Info sheet 2019-09 2019-Aug-29

NEW MATERIAL IN THE OLD STANDARD REAR AXLE

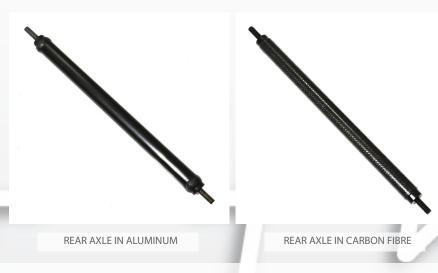
We have updated the material of the tube on the old standard rear axle, with carbon fibre instead of aluminum that we used before.

This change implicate that the older standard rear axle will have the same material as the present standard rear axle.

It gets lighter and stiffer.

UPDATED		
ART.NO.	DESCRIPTION	CHANGE
3301133	Tube rearaxle w bult 33	tube in carbon fiber instead of aluminum
3301136	Tube rearaxle w bult 36	tube in carbon fiber instead of aluminum
3301139	Tube rearaxle w bult 39	tube in carbon fiber instead of aluminum
3301145	Tube rearaxle w bult 45	tube in carbon fiber instead of aluminum
